AGENDA PORTLAND PLANNING BOARD MEETING

To: Sean Dundon, Chair and Members of the Portland Planning Board
 From: Andrew Tufts, Planner
 Date: June 7, 2019
 Re: Mixed-Use Redevelopment, 40 Free Street, 40 Free, LLC
 Project #: PL-000602-2019 CBL: 038 1018001
 Meeting: June 11, 2019

PLAN CORRECTIONS REPORT PL-000602-2019 FOR CITY OF PORTLAND

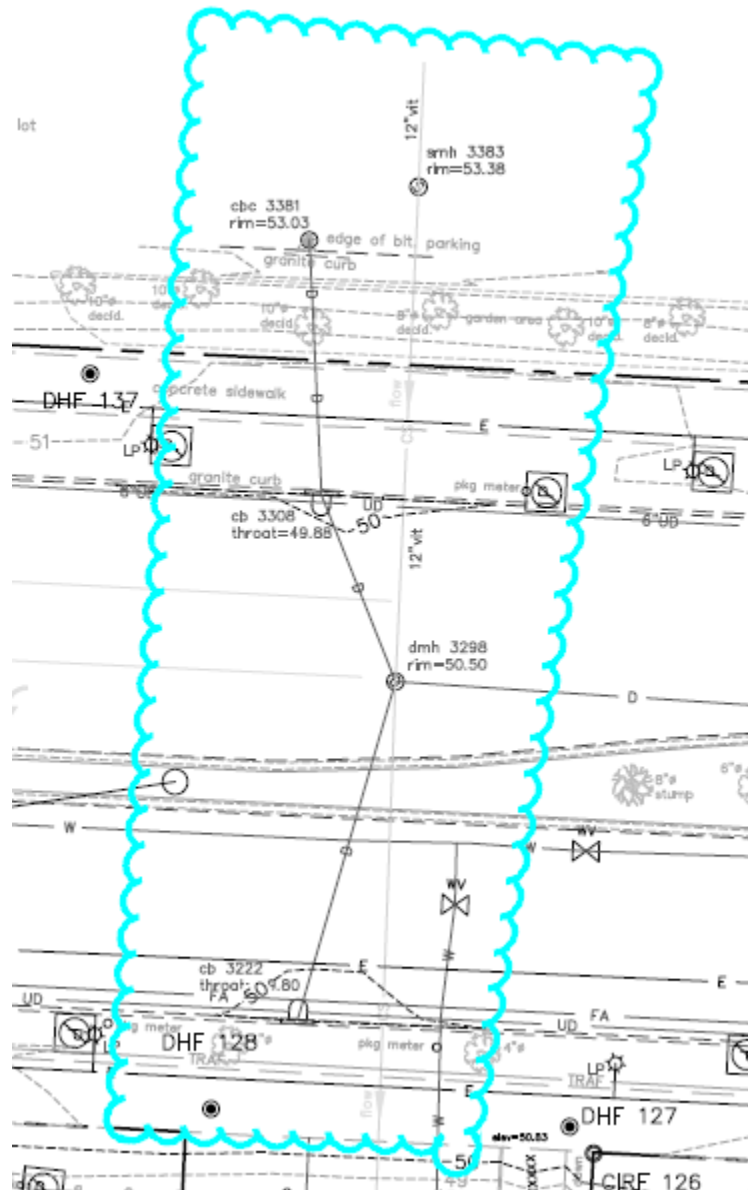
Comment - Existing Conditions:

Response – a. The conduit has been added to the plans on opposite side of Free St.
 b. Services are abandoned per the plan titled Mainway Renewal Project, by FST General Plan – Part 1 Free Street, dated July 1972, Sheet 5 of 26. Drawing clip is below.

c. The Plan is to install a catch basin within the parking lot and utilize the existing 12" drain as an outlet. The drain is tributary to DMH 3298 within Spring St per the Spring/Middle Arterial Streetscape Plan Existing Conditions Plan, dated Nov. 21, 2013, Sheet 4 of 5.

FIRST FLOOR PLAN
1"=20'

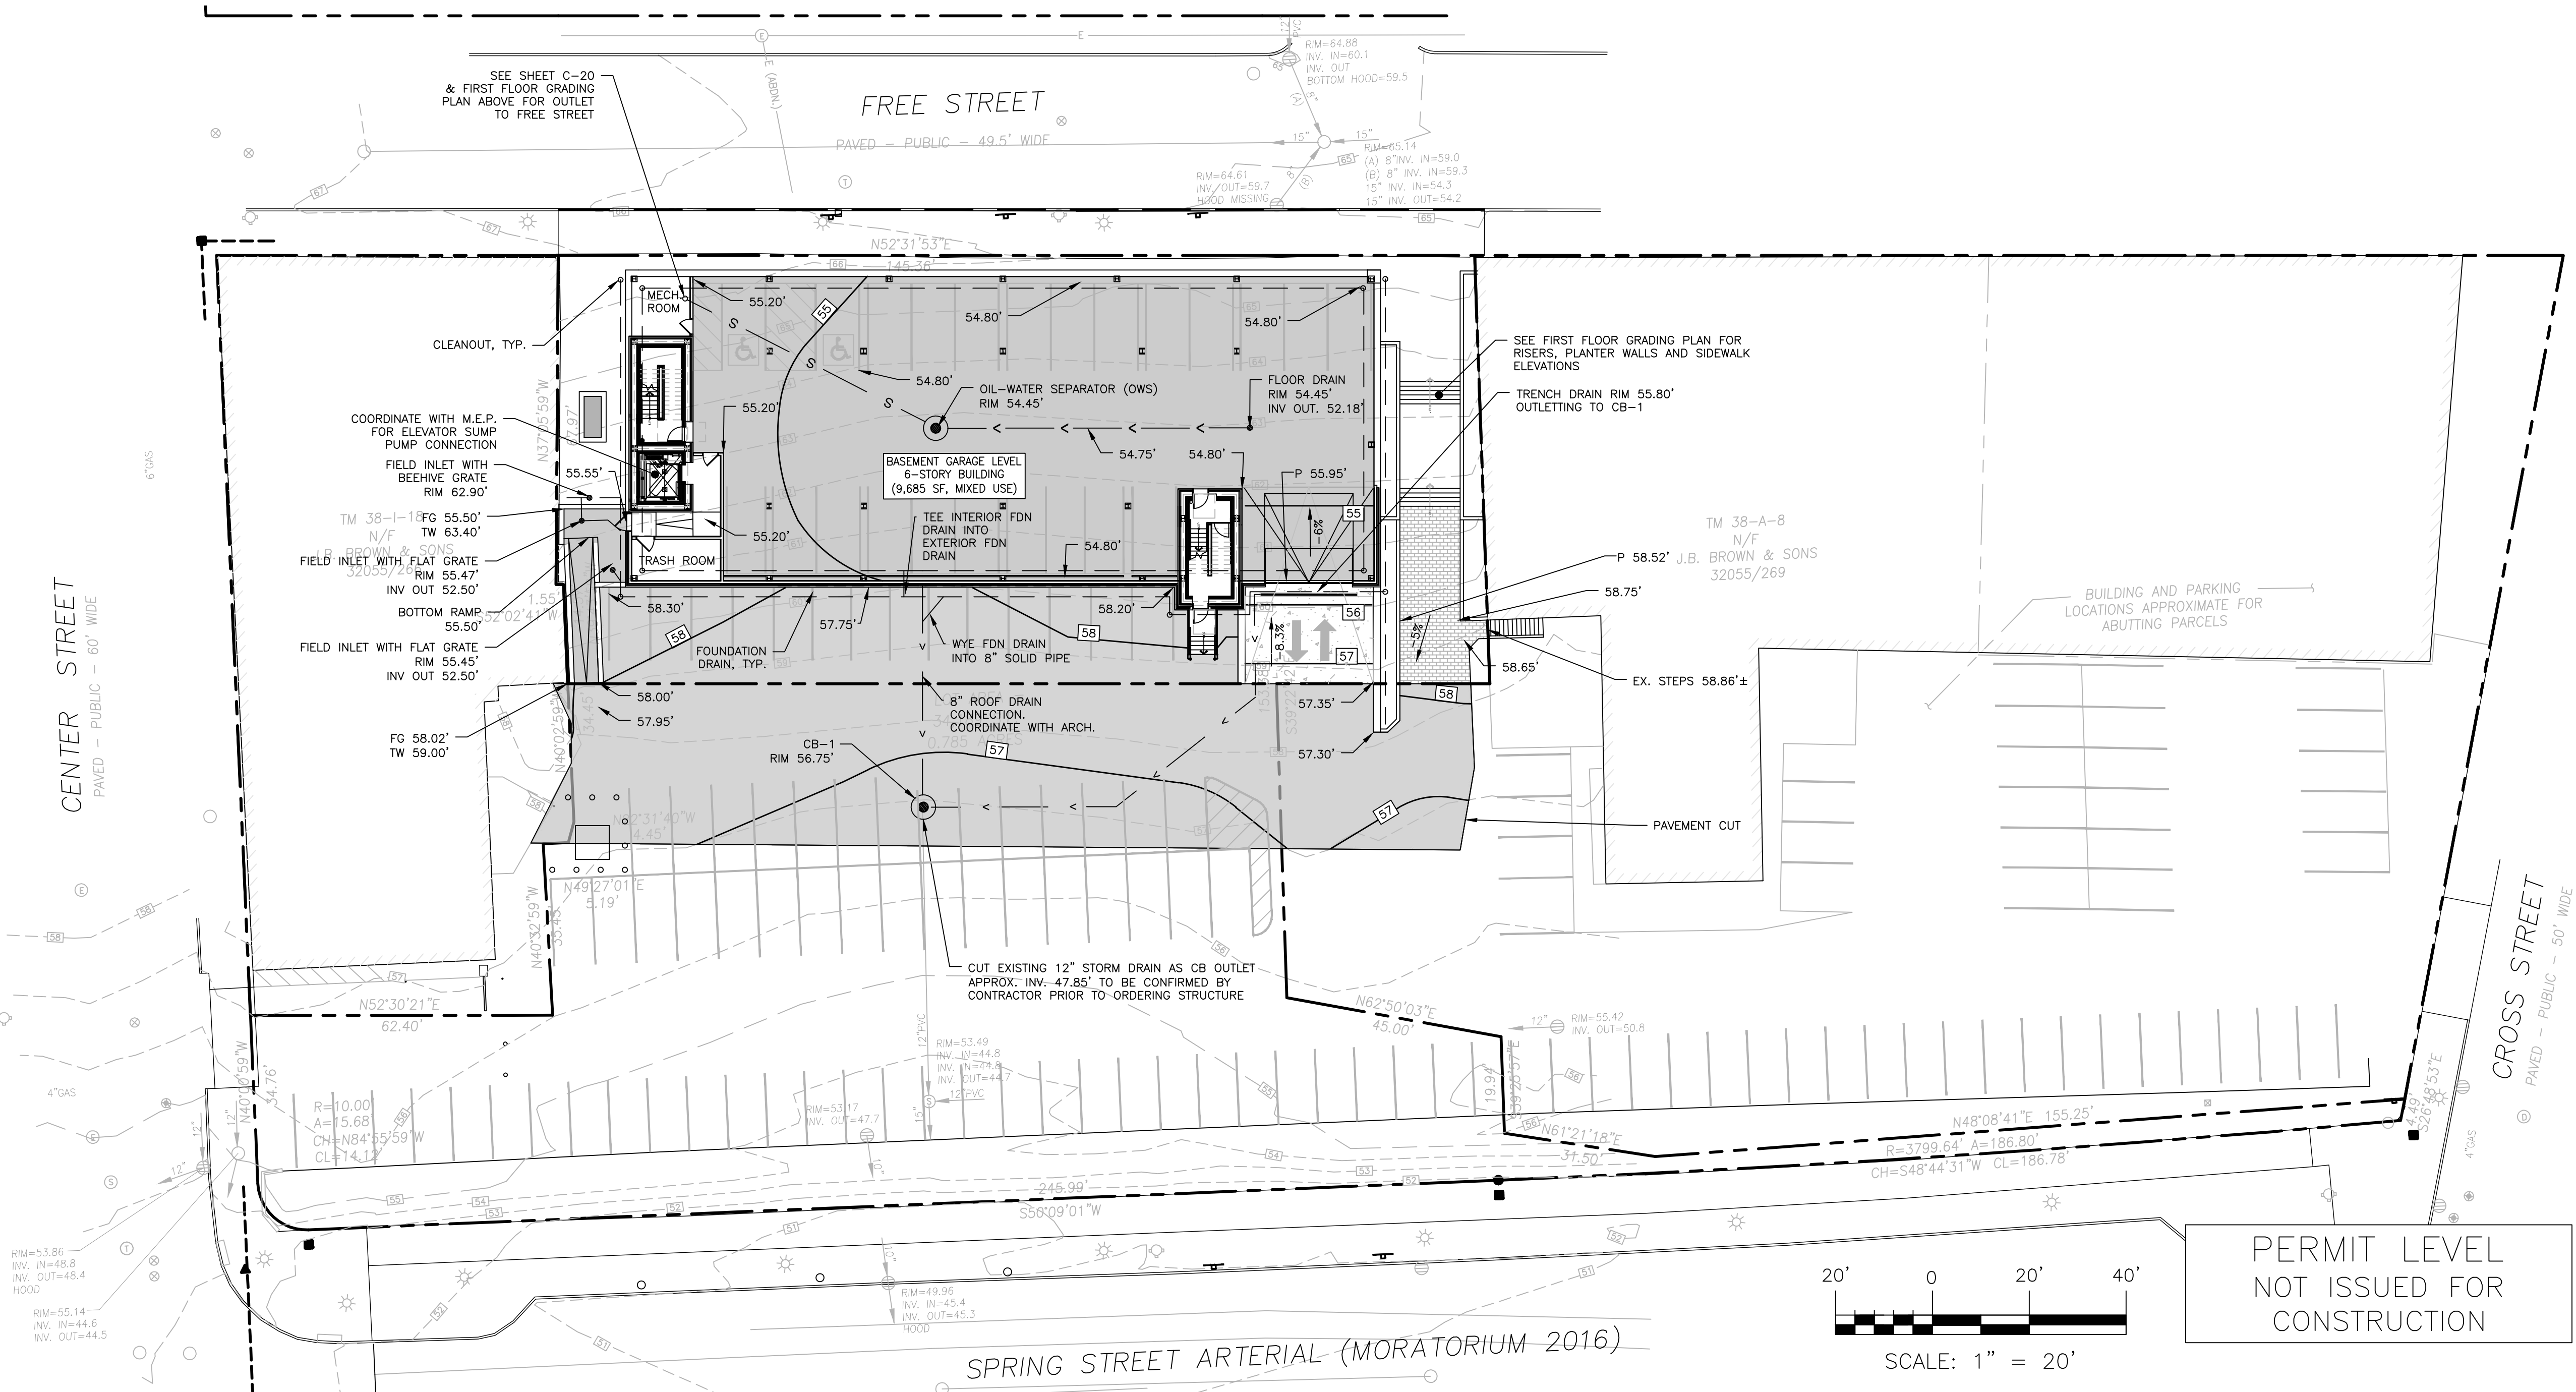
3. Additional clarification should be provided on the area to the west of the proposed building.
 - a. The project is proposing to fill against the existing building on the corner of Center Street and Free Street, and it also appears that a retaining wall will be built against the existing building in some areas. The Applicant should confirm that this change to the adjacent building on another property will be acceptable, and that a construction easement or some other type of agreement isn't required.

4. Proposed contours are not shown on the stairs to the east of the proposed building. Slope arrows indicate a change in grade before the brick area transitions to pavement (1.2% to 4.4%). Additional spot grades and topography lines should be provided to show how this area is graded.
